Exelon Generation Company, LLC  
Byron Station  
4450 North German Church Road  
Byron, IL 61010-9794

January 12, 2007

Byron Station, Units 1 and 2  
Facility Operating License Nos. NPF-37 and NPF-66  
NRC Docket Nos. 50-454 and 50-455

Subject: Inservice Inspection Program Second Interval Relief Requests I2R-21, I2R-22, I2R-23,  
I2R-25 and I2R-53

Figure 2: Scan Obstructions

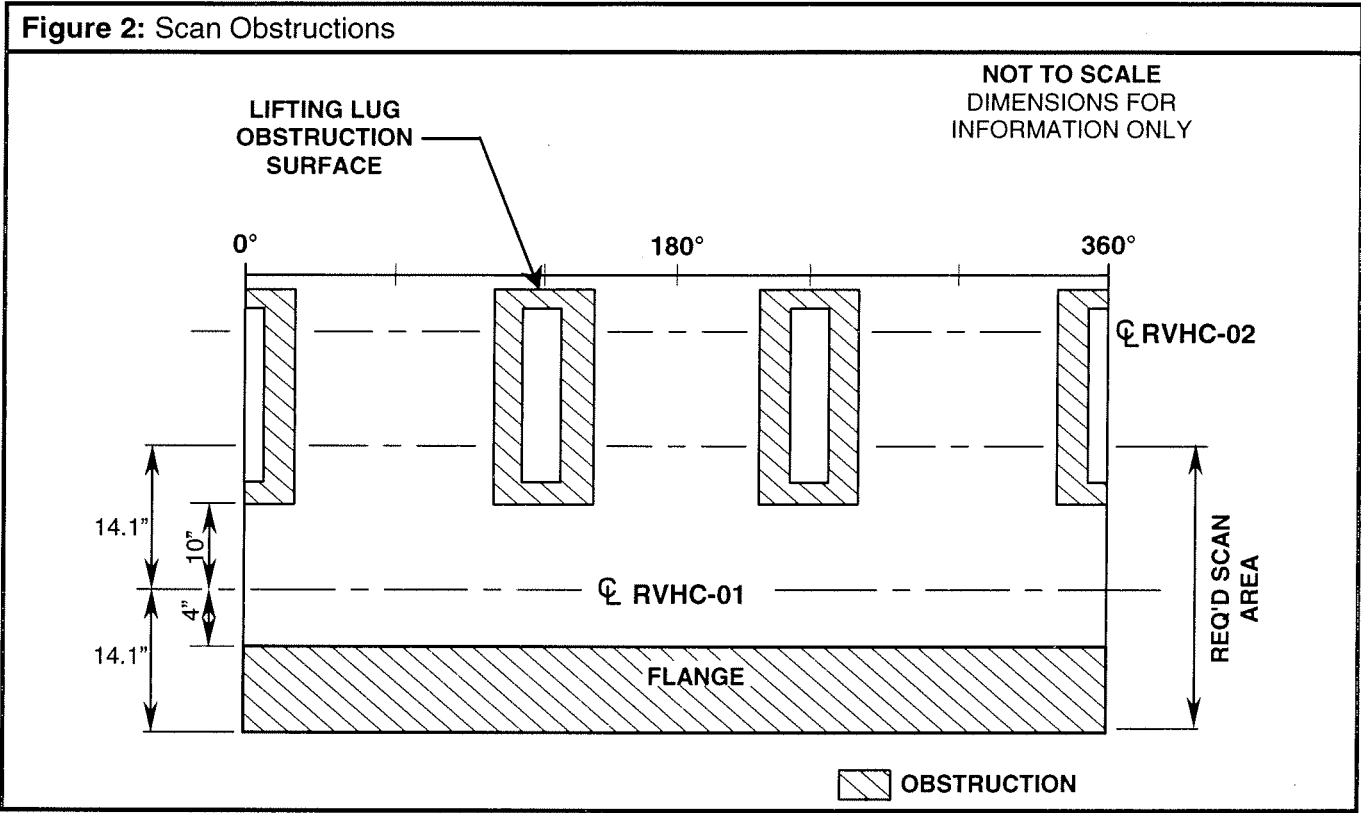
In addition to the flange, parts of the three large head lifting lugs also fall in the required scan area. A diagram of the transducer position for actual and required coverage is shown in Figure 2 illustrating the obstructed areas.

The obstructed volumetric examination, along with the surface examination, and the visual (VT-2) examinations that are performed every refuel outage will provide reasonable assurance of the continued structural integrity of the weld. Furthermore, past Preservice and First Interval examinations have revealed no recordable indications. Byron Station performed the Code required volumetric examination of the Reactor Vessel Head-to-Flange weld to the maximum extent possible for current techniques.

**Figure 2: Area Achieved for Each Beam Angle**

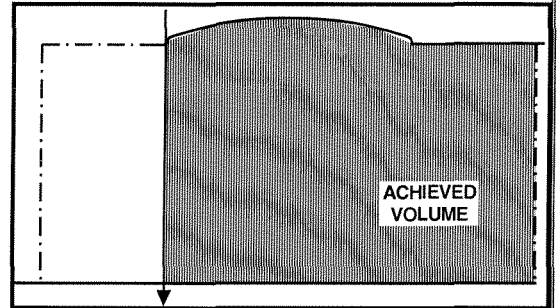
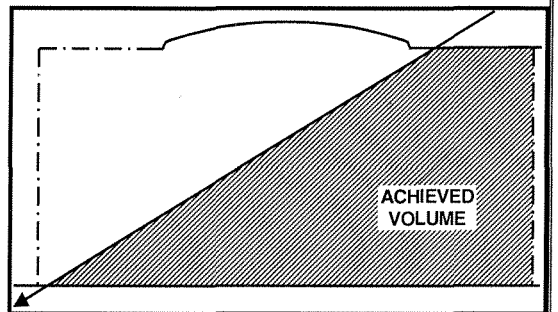
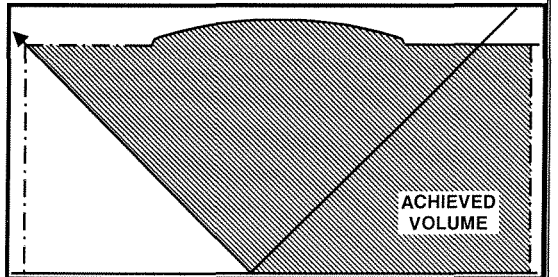
The volumetric examination of the shell-to-flange weld is obstructed on the flange-side due to the proximity of the flange. Scanning perpendicular (axial) to the weld was restricted to the shell-side only. The 45° Shear wave examination was supplemented with scanning from the shell-side with a 60° Refracted Longitudinal beam. Additionally, the transducers were obstructed from scanning forward of the points shown by the transducer lift-off at the toe of the weld resulting in loss of signal. There are no additional obstructions for the entire length of the weld.

For the 45°Shear, the area obtained was from the flange-side of the weld to a distance of ½ inch beyond the weld toe on the shell side (B-C).

For the 60°RL, the area obtained was the from the maximum exit point to the required area on the shell side (B-C).

For the 45°Shear, the area obtained was the from the 2<sup>nd</sup> leg maximum exit point to the required area on the shell side (B-C).
